Submit 1 Copy To Appropriate District Office State of New Mexico	
District I – (575) 393-6161 Energy, Minerals and Natural 1	Resources Revised July 18, 2013
1625 M. French Dr., Hobbs, NM 88240 <u>District II</u> – (575) 748-1283	WELL API NO. 30-015-31941
811 S. First St., Artesia, NM 88210 OIL CONSERVATION DI	V ISION 5 Indicate Type of Lease
District III – (505) 334-6178 1220 South St. Francis 1000 Rio Brazos Rd., Aztec, NM 87410	Dr. STATE STEE
District IV – (505) 476-3460 1220 S. St. Francis Dr., Santa Fe, NM Santa Fe, NM 87505	6. State Oil & Gas Lease No. VO-4949
SUNDRY NOTICES AND REPORTS ON WELLS (DO NOT USE THIS FORM FOR PROPOSALS TO DRILL OR TO DEEPEN OR PLUG B	7. Lease Name or Unit Agreement Name ACK TO A Grande Mike AZK State
DIFFERENT RESERVOIR. USE "APPLICATION FOR PERMIT" (FORM C-101) FOR SUPROPOSALS.) 1. Type of Well: Oil Well Gas Well Other	8. Well Number
Type of Well: Oil Well	9. OGRID Number

Yates Petroleum Corporation	025575
3. Address of Operator	10. Pool name or Wildcat
105 South Fourth Street, Artesia, NM 88210	County Line Tank; Abo
4. Well Location Unit Letter K: 1650 feet from the South	line and 1550 feet from the West line
Section 2 Township 16S Range	29E NMP

Well Name: Grande Mike AZK State #1 Field:

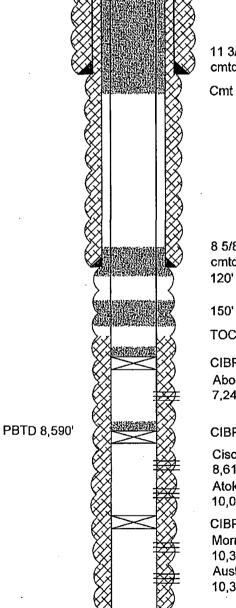
1. MIRU all safety equipment as needed. Spot 25 sx Class "C" cement on t	op of CIBP at 7193'
2. Perforate 5-1/2" casing at 5200'. Spot a 150' Class "C" cement plug insi 3. Tag cement plug, then perforate 5-1/2" casing at 2650'. Spot a 120' Class	de and outside casing from 5200'-5050'. WOC.
2530' (this will cover the 8-5/8" casing shoe). WOC.

4. Tag cement plug, then perforate 5-1/2" casing at 435'. Circulate a Class surface (this will cover the 11-3/4" casing shoe).	"C" cement plug inside and outside casing from 435' up to

5. Cut off wellhead, install dry hole marker and clean location.	
ly i as	or plugging of well bore only. der bond is retained pending receipt
Wellbore schematics attached Of C-103 (S	ubsequent Report of Well Plugging)
which may	be found at OCD Web Page under scmnrd.state.nm.us/ocd. MM OIL CONSERVATION
Approval Granted providing work is Rig Release Date:	ARTESIA DISTRICT
Completed by 3-18-2016	MAR 1 6 2015
i nereoy-certify-that the -moralism and complete to the best o	f my knowledge and belief
Thereby contri, that the information and the complete to the cost of	RECEIVED 14
SIGNATURE (In Heurte TITLE Regulato	ry Reporting Supervisor DATE March 16, 2015
	yatespetroleum.com PHONE: 575-748-4168
For State Use Only	AS MUMA alohan
APPROVED BY: // JUST TITLE //STC	MARQUISON DATE 3/18/2015
> See Attached CO	Ai
